Southern California Edison Company

December 20, 1984

Subject: Docket No. 50-206
Masonry Wall Test Program
San Onofre Nuclear Generating Station
Unit 1

FIGURE 1.1 : GENERAL VIEW OF STRUCTURE

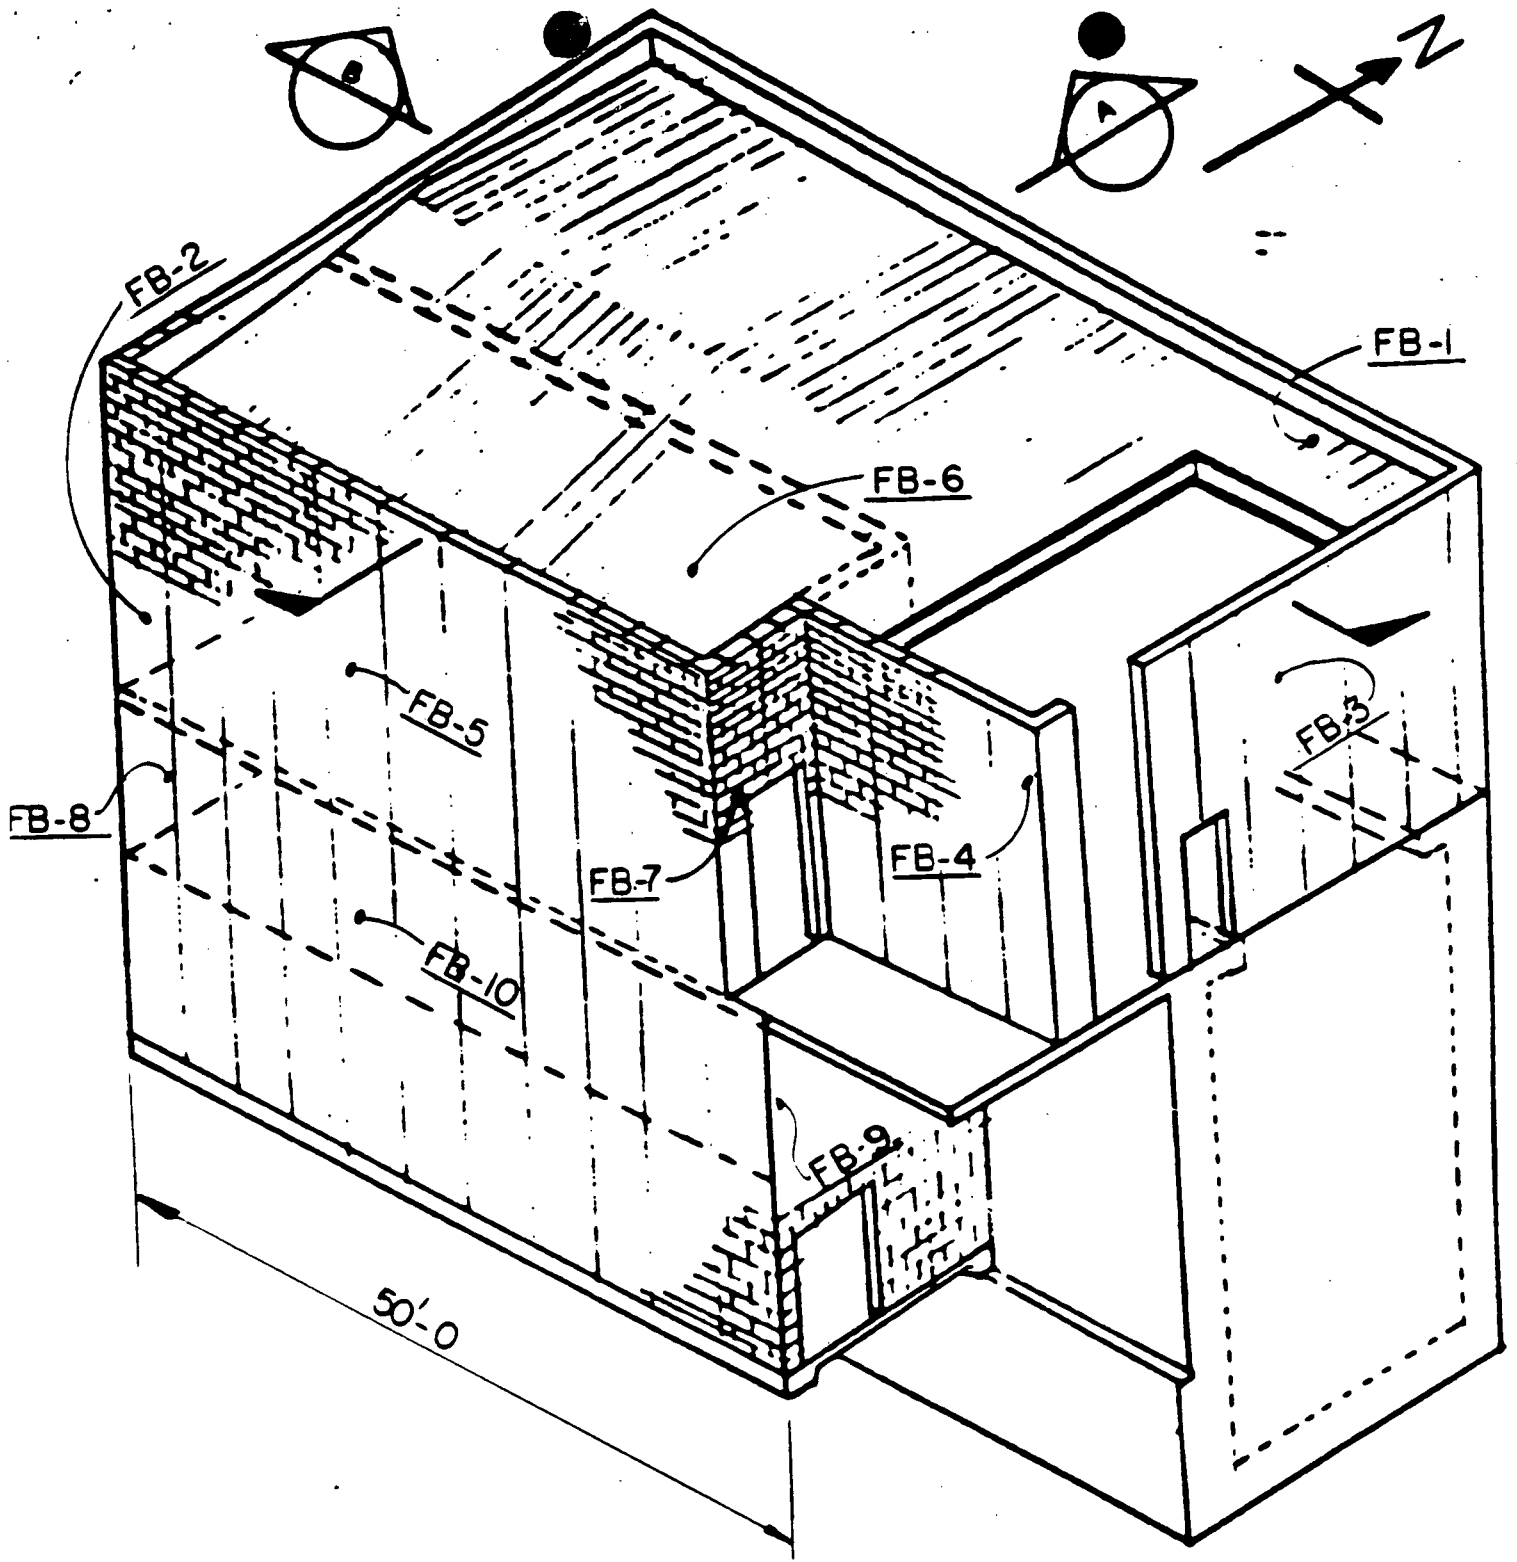
Document that the walls around the 480V Switchgear Room are the only walls where Section M on Drawing 568140 are applicable.

The only walls where Section M is applicable are the Fuel Storage building masonry walls FB-5 and the southern 18' portion of wall FB-2 (see Figure 1.1). However, the test walls for the Fuel Storage building represent all the walls above elevation 42', that is, walls FB-1 through FB-7. The bottom connection of all the remaining masonry walls are equal to the connection used in the test program.

FIGURE 3.1 SONGS-1 FUEL STORAGE BLDG.
AS-BUILT DETAIL AT EL 42'-0

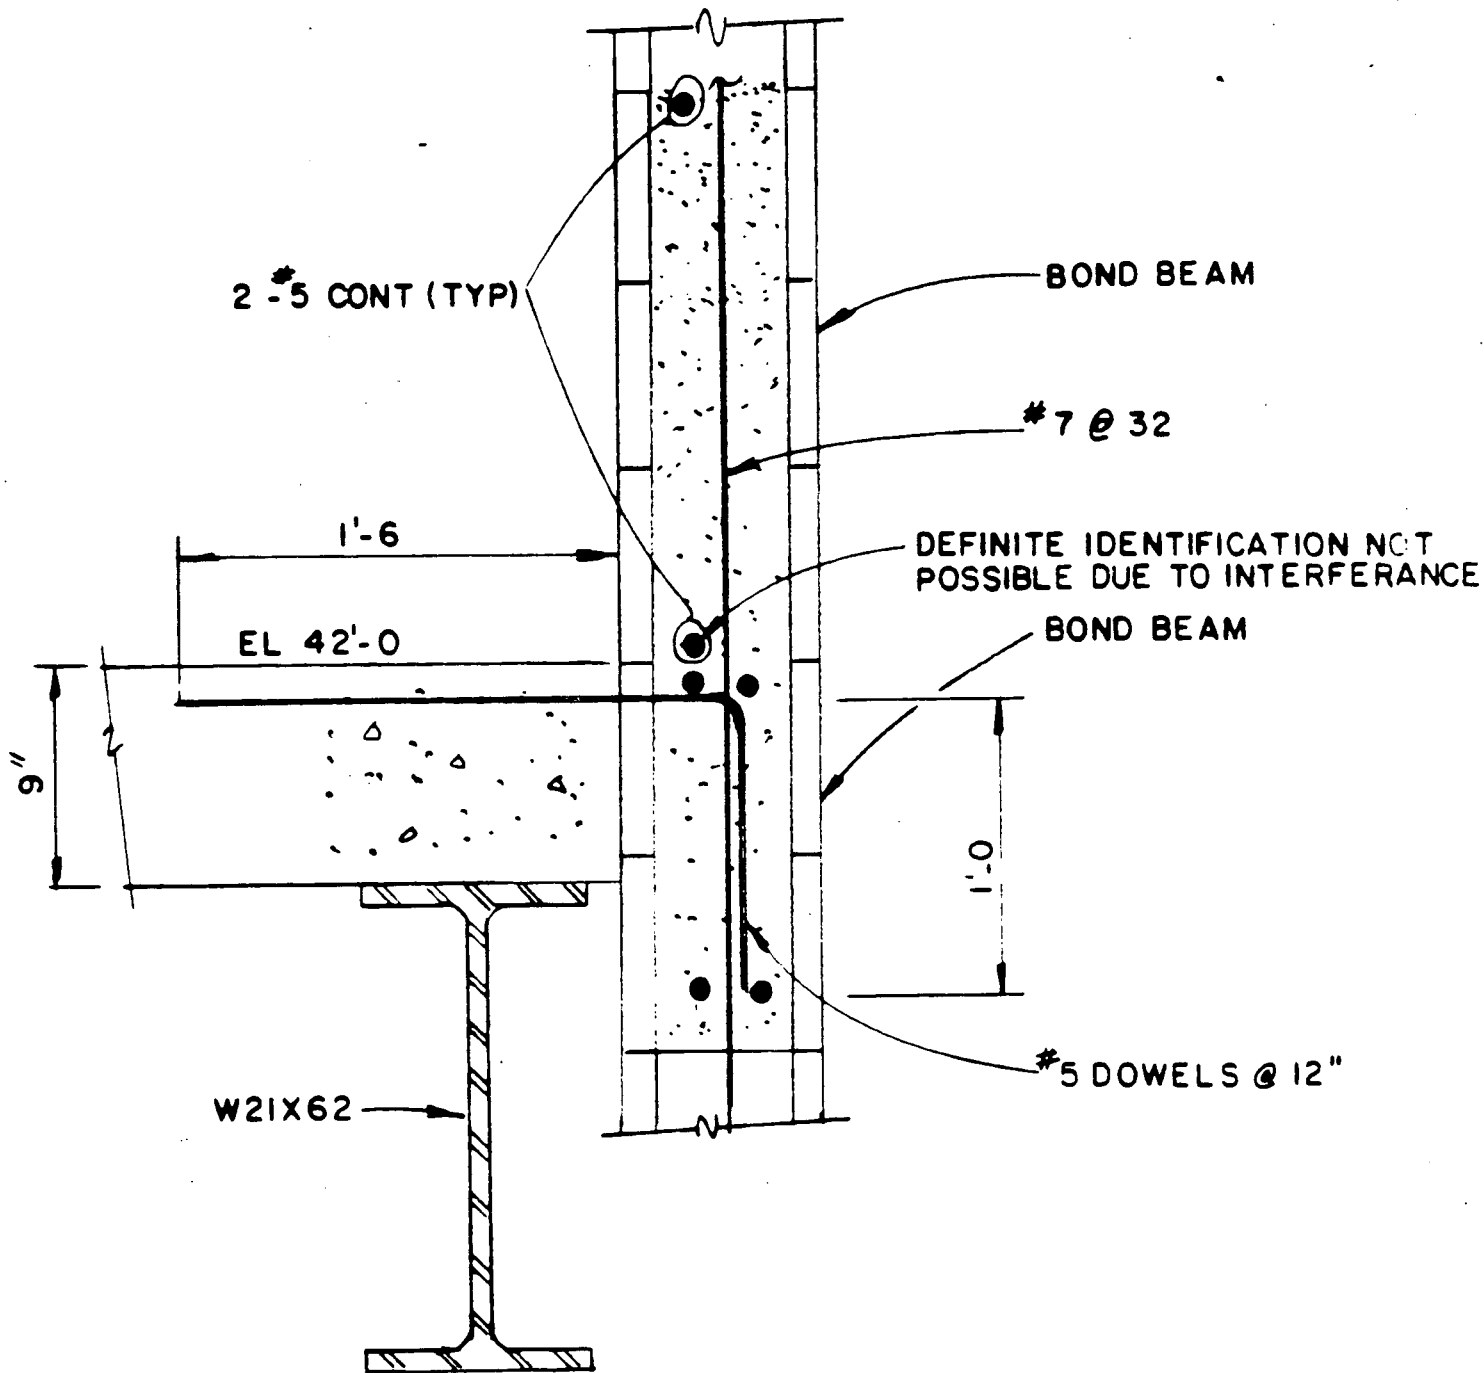
For wall FB-5 verify the extent of grouting above elevation 42'.

Section M of Drawing 568140 does not explicitly describe the extent of grouted cells above elevation 42'. To verify whether the cells were grouted or not, a field investigation was made. At two locations, about 30' apart, holes were drilled into the first three cells above elevation 42'. The holes were situated about halfway between the vertical rebar. Grout was encountered in all holes. In addition, it was found that there was a continuous horizontal bar in or slightly above the third cell. This investigation indicates that there is a bond beam above elevation 42', with an "as-built" condition as shown in Figure 3.1.

FIGURE 4.1 : ANALYTICAL STRESS AND STRAIN PROFILES

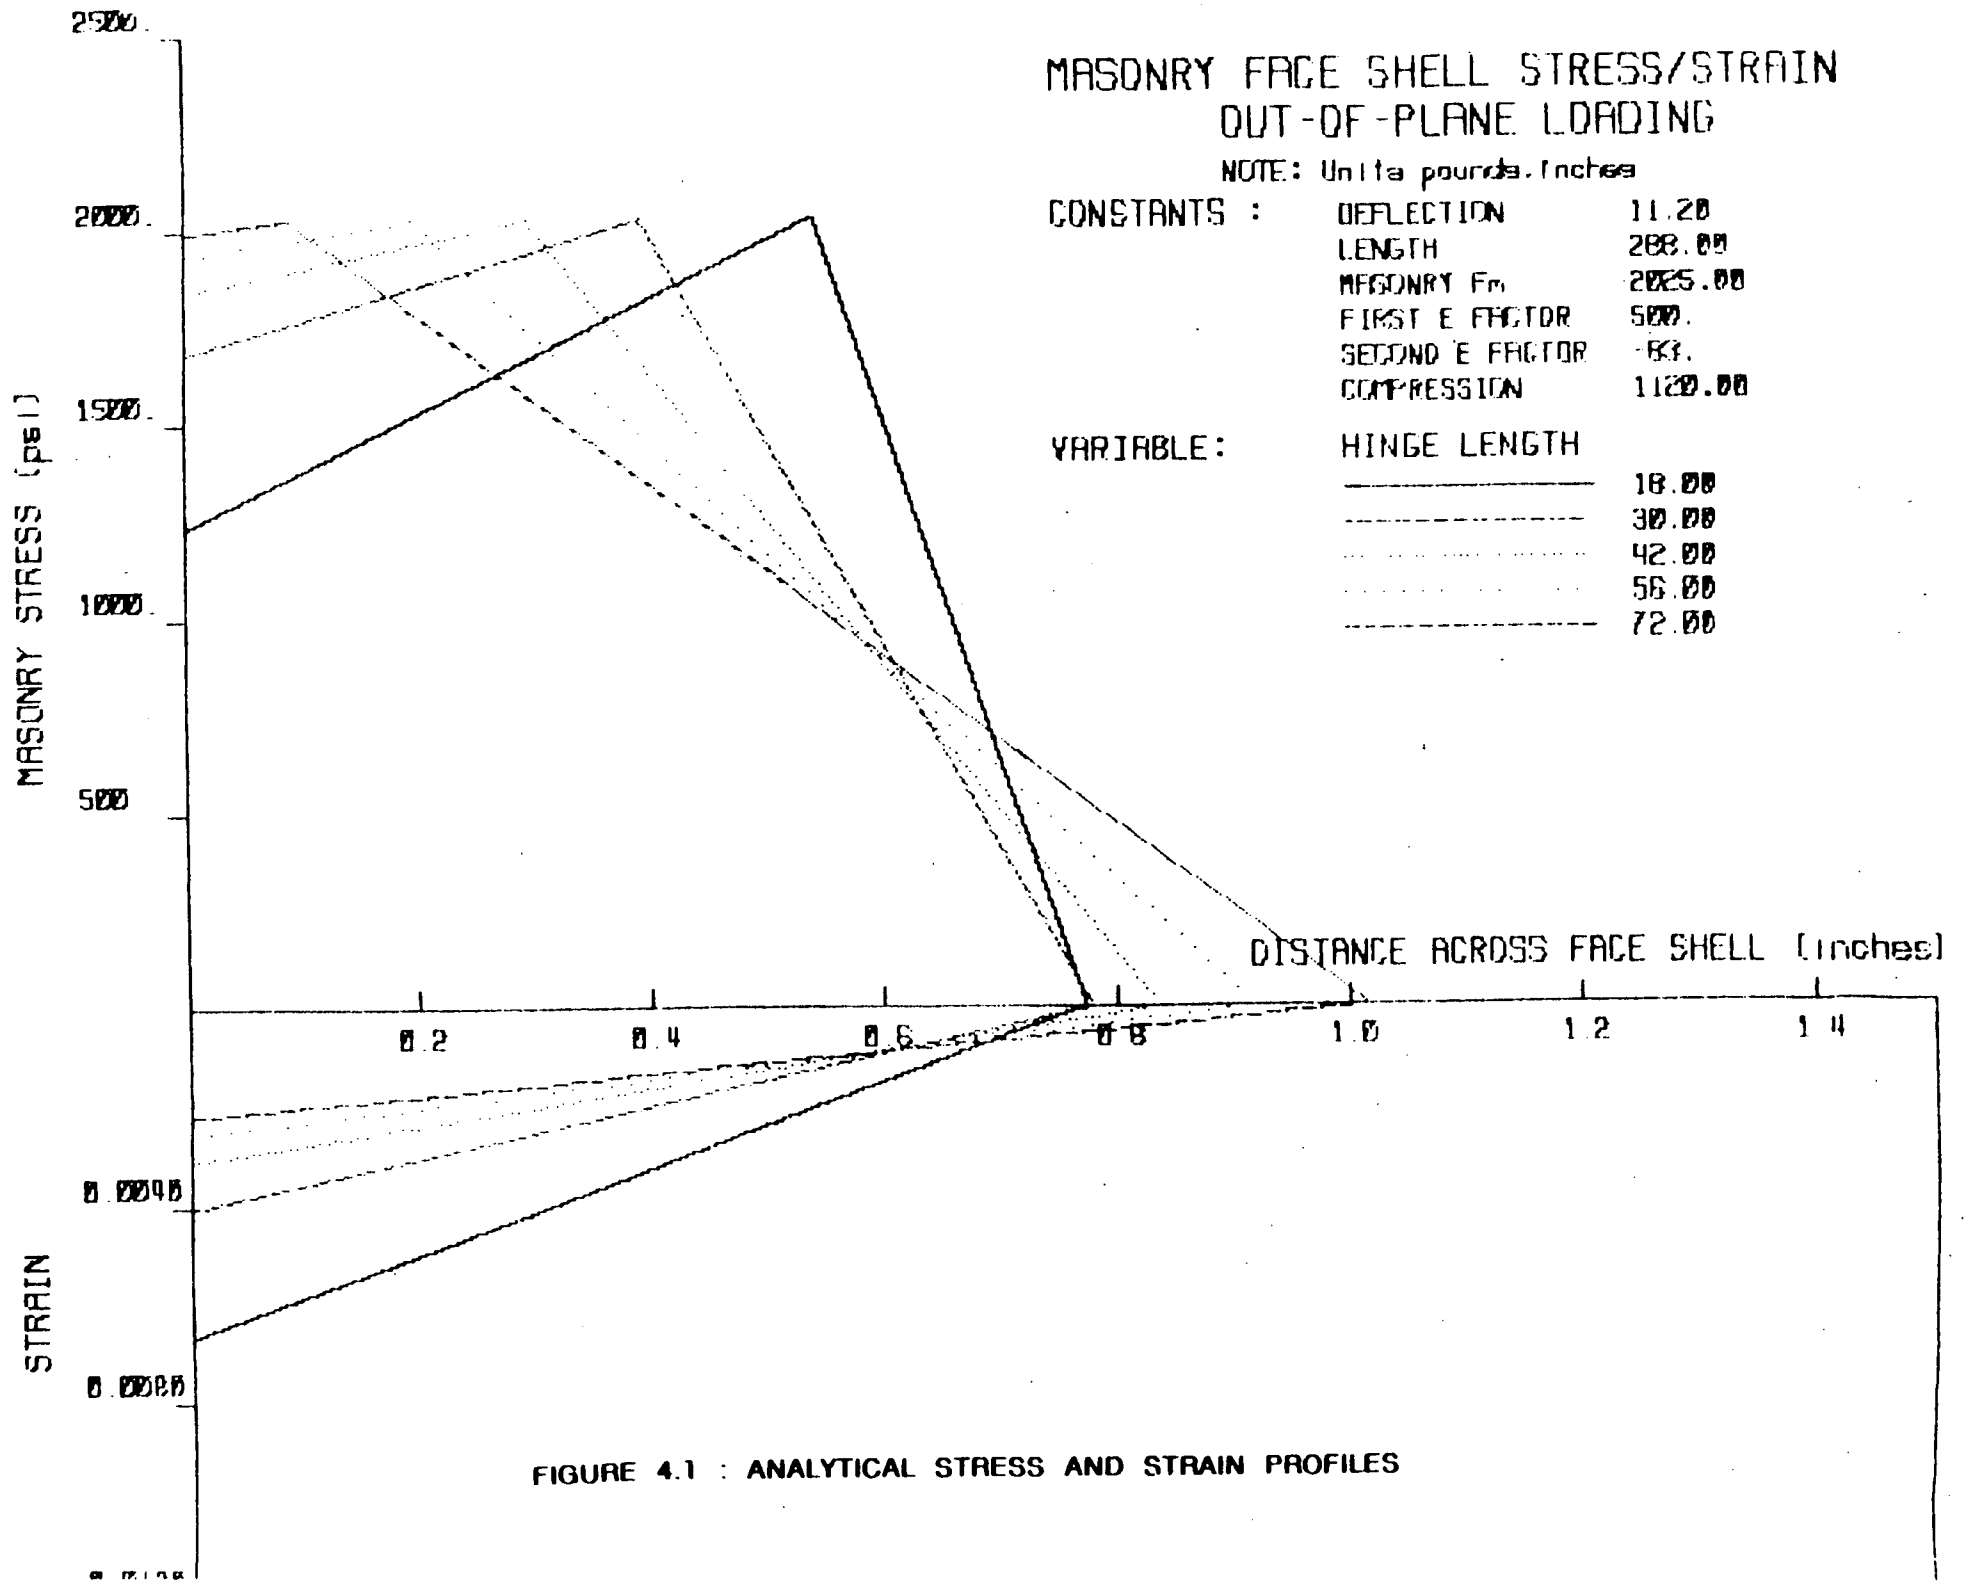
Examine the stress-strain profiles for both the test results and the analytical results to determine the position of the neutral axis.

The results of the computations are summarized in Table 4.1 and Figure 4.1. Table 4.1 lists the maximum strains and the distance from the extreme fiber to the neutral axis for various values of plastic hinge length. In Figure 4.1 the strains are plotted below the horizontal line representing the face shell and the stress distribution corresponding to the strains are plotted above the line. For the plastic hinge lengths used, the lower value (18") would correspond to the base hinge and the larger values (42" to 72") would be appropriate for the mid-height hinge. Therefore, maximum strains at the base hinge would be of the order of 0.0067 with a neutral axis 0.78" into the face shell. For the upper hinge the strains would be 0.0030 with depths to the neutral axis of about 0.8" to 1.0". Note that at the base, even though strains are higher, the neutral axis depth is less because of the higher curvature associated with the lower plastic hinge length.

At the time the April 30, 1982 response was prepared, a limit of 0.004 was suggested for the extreme fibre strain. Beyond this strain the potential for face shell spalling would exist. In fact, the indicated values of strain in Figure 4.1 and Table 4.1 show that spalling would not occur at the mid-height hinge but would be a possibility at the base. In the test, no spalling occurred at mid-height and only minor spalling at the base occurred, i.e., approximately 1/4" to 1/2" into the block.

The maximum depth to the neutral axis at the wall base has been computed to be approximately 0.7 inch, or less than one-half of the actual face shell thickness. On this basis even with spalling up to 3/4 inch, the neutral axis would remain in the face shell. The tested walls exhibited spalling about one half this value.
